Permit Number: 030538

This is to certify that Lindsay Scott A
has permission to Replace 3 sets of exterior steps add 7'5" deck change one window to a door
AT 12 Lewis St 056 A010001

RE:
 SCOTT LINDSAY
 10-12 LEWIS STREET
 BUILDING PERMIT

DECK DETAILS 10-12 LEWIS ST
 1 1/2" = 1'-0" 2 JUNE 03

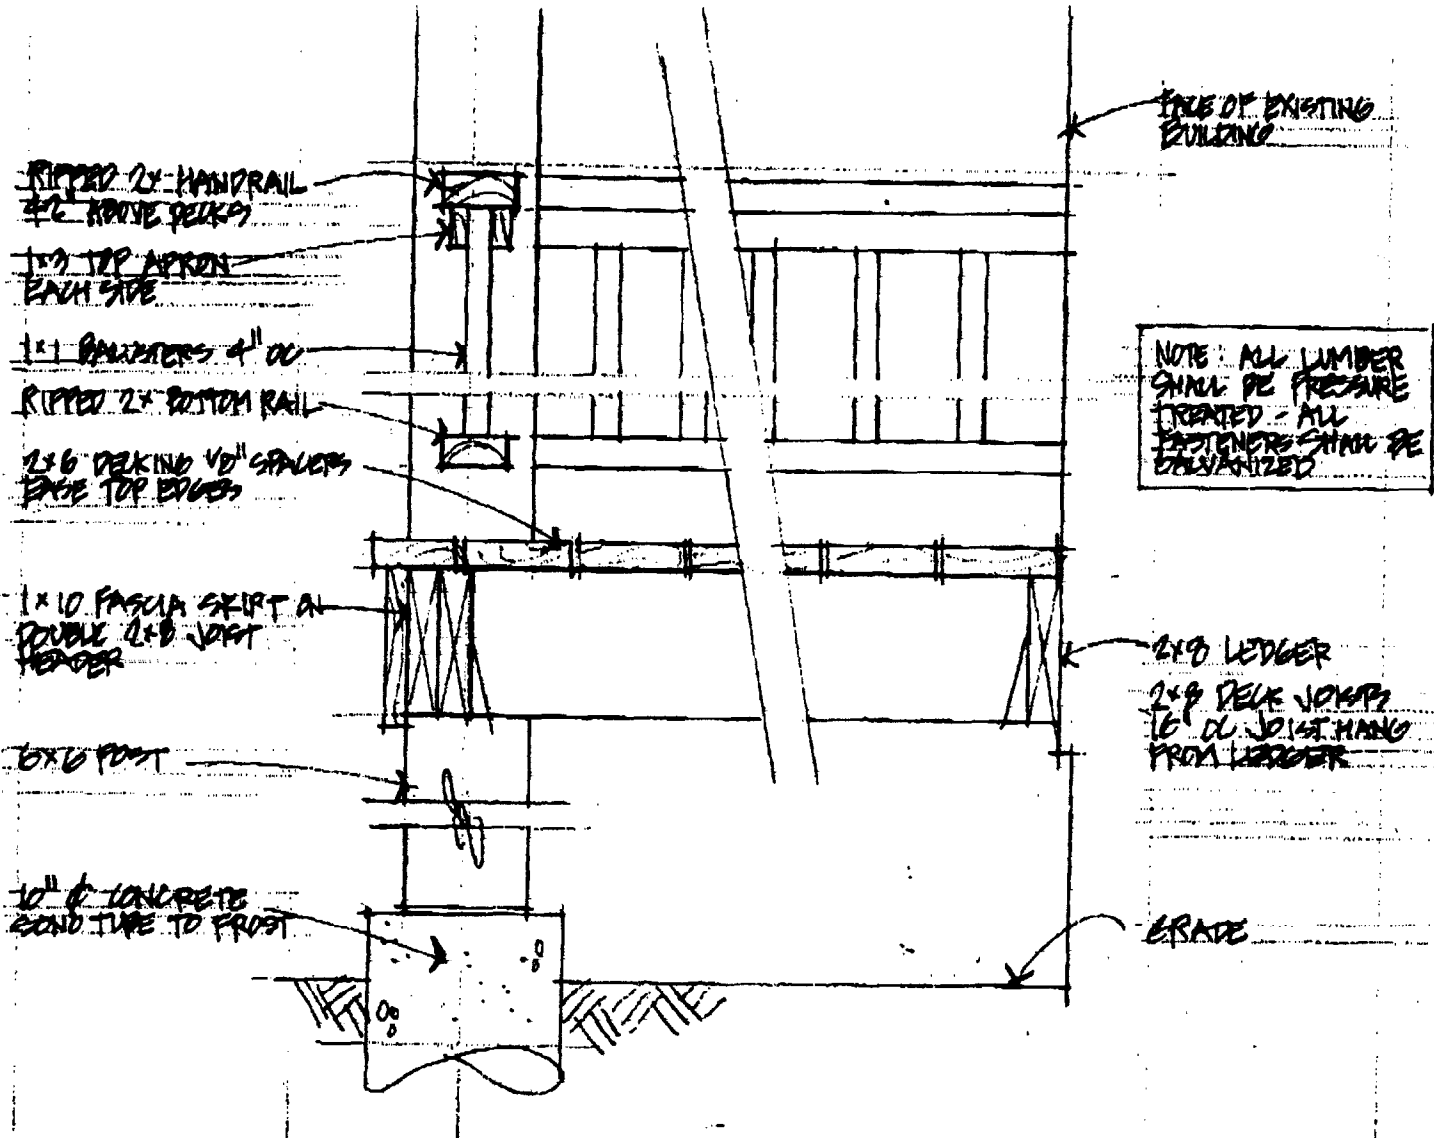
06/02/2003-mjn: Need complete structurals, guard details, left message with applicant

NOTE: ALL LUMBER SHALL BE PRESSURE TREATED - ALL FASTENERS SHALL BE GALVANIZED

PROPOSED ENTRY / DECK
10-12 LEWIS STREET, PORTLAND
1/4" = 1'-0" 14 MARCH 03
REV 7 APRIL 03
15 MAY 03

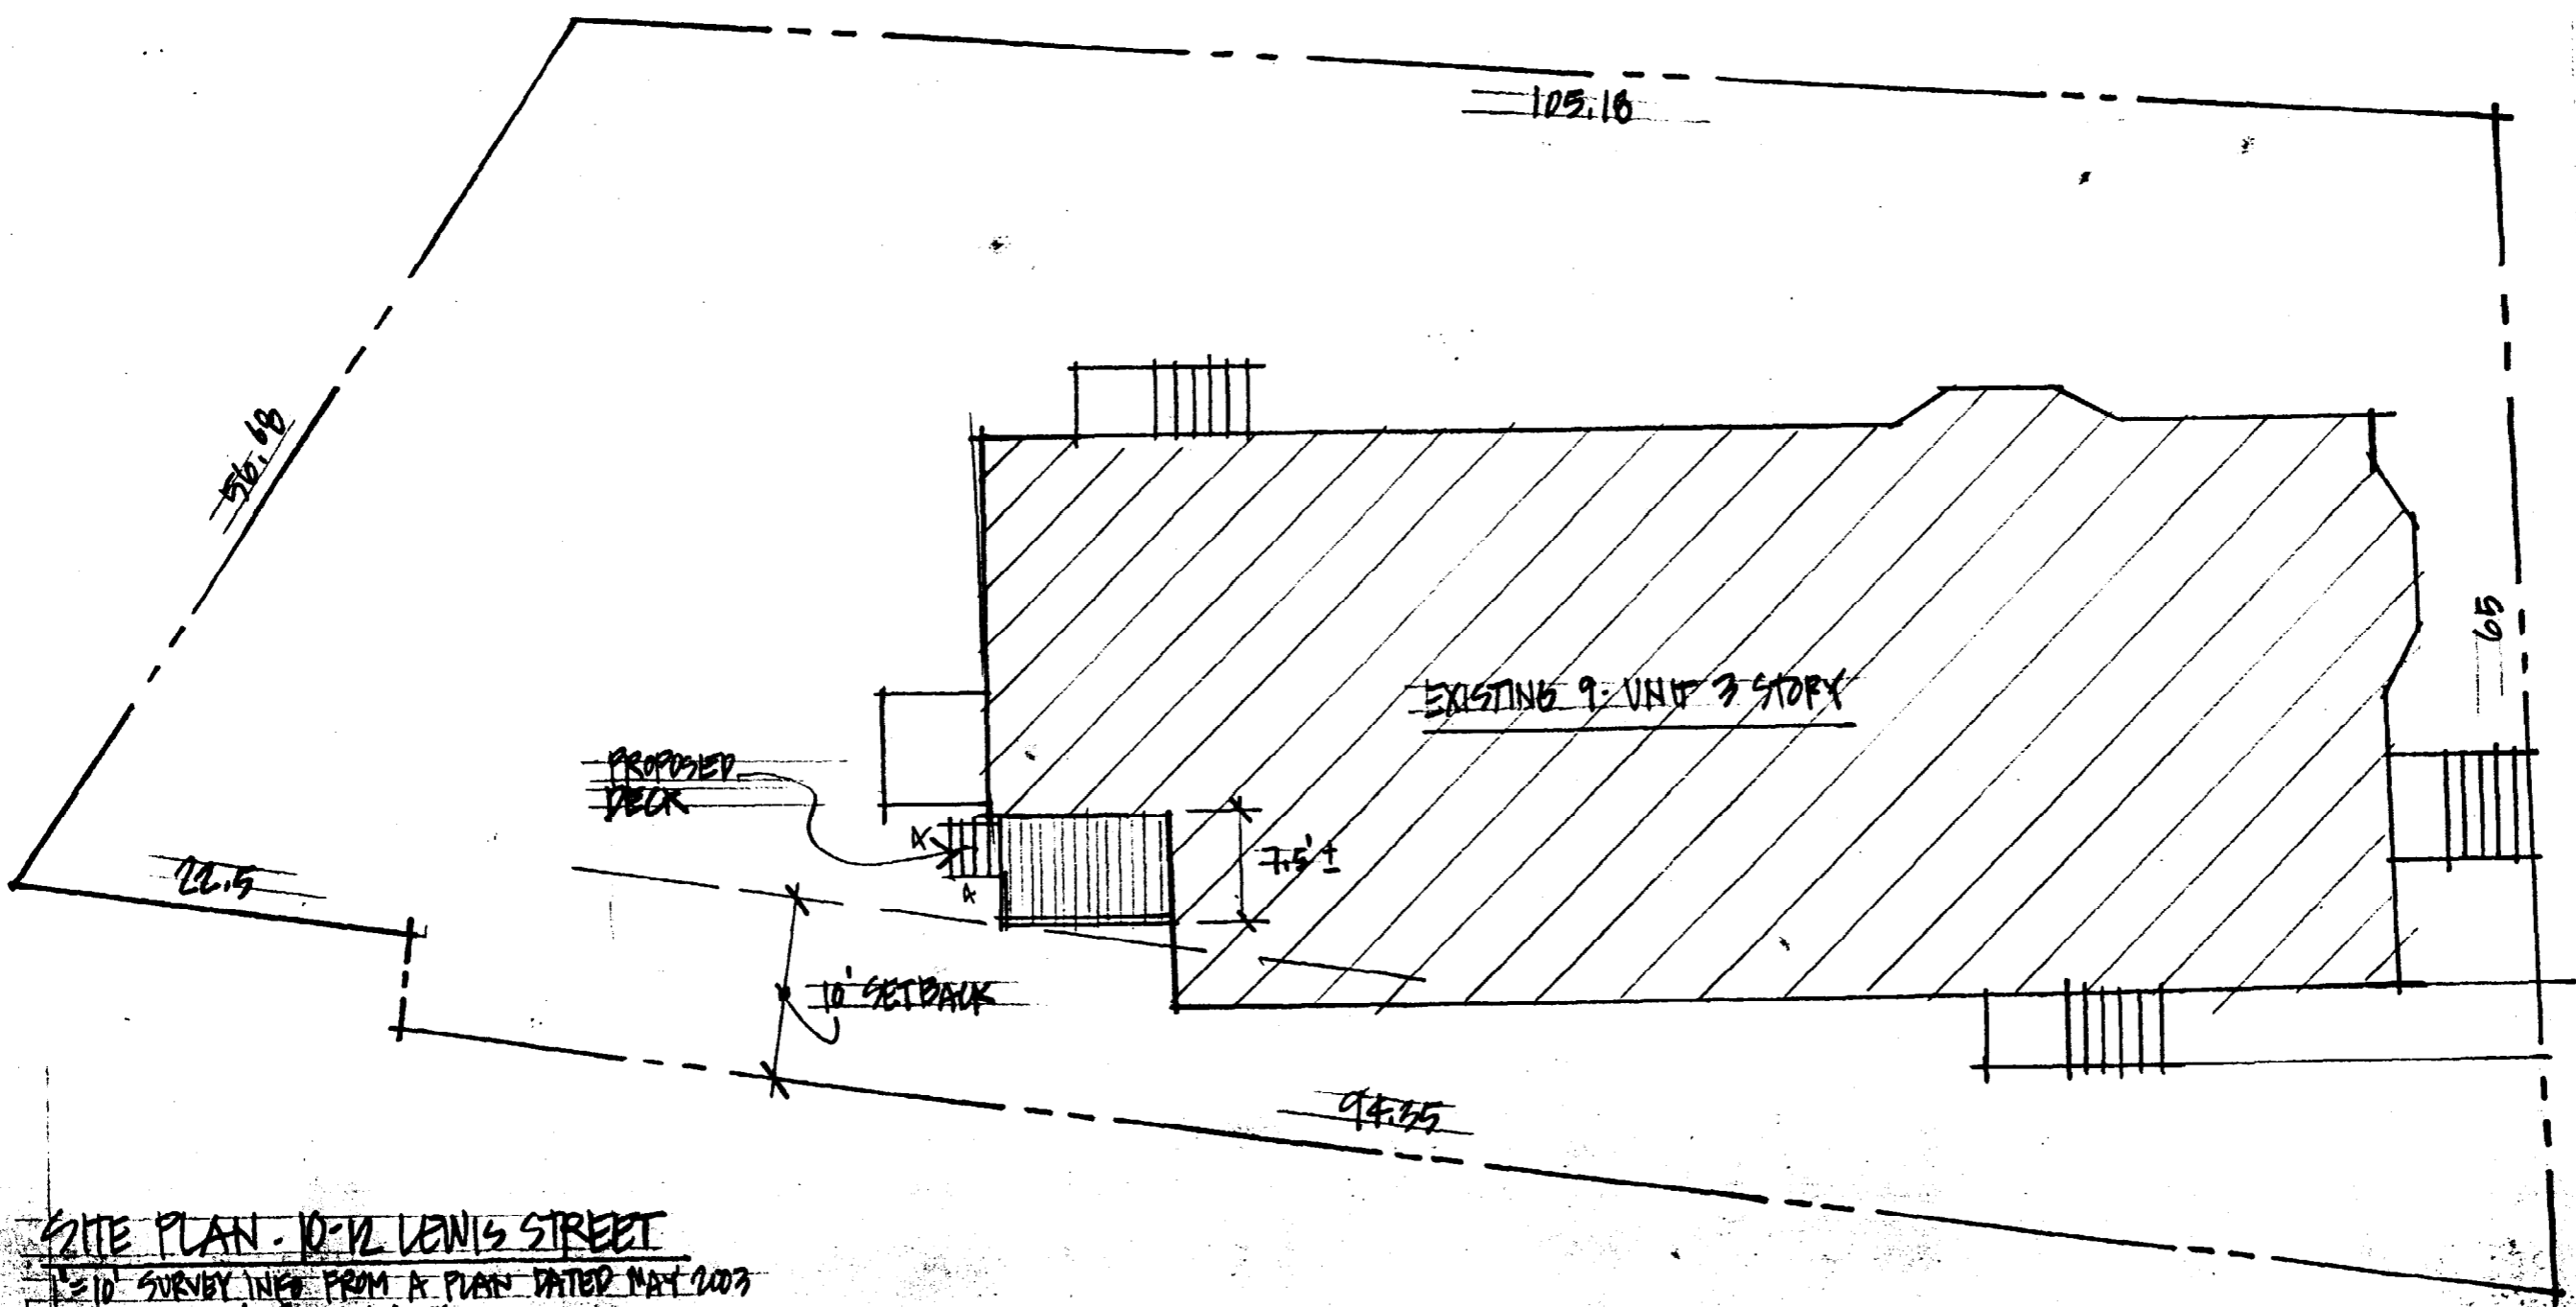
NOTE when connecting open exterior stairways permitted - only 1st floor from ground access

7/11
TRENDS RISE PER GREEN HARBOR
